Accessibility Survey

City of Downey Gainford Street - Brookshire Avenue to Bellder Drive

Date of Inspection
7/13/2017

Disability Access Consultants

South Side @ 33.952317863341, -118.120198845863

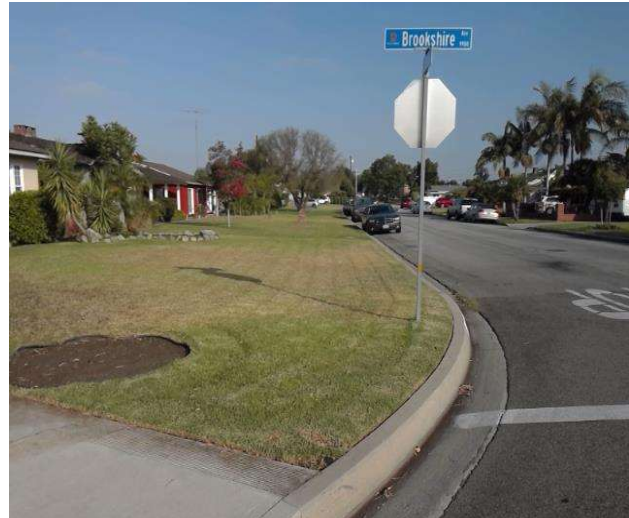
Sidewalks : No Sidewalk

No sidewalk exists at the location.

No action necessary until a sidewalk is provided.

Sidewalk East of Downey Avenue @ 33.953982071886, -118.123314231634

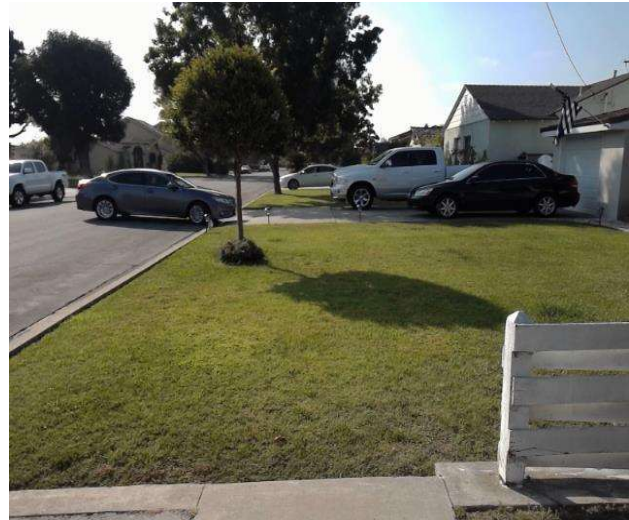
Sidewalks : Missing Sidewalk

Section of sidewalk is missing and consists of dirt, grass or gravel.

On-Site Finding 570.00 feet

Provide a compliant sidewalk for the missing section.
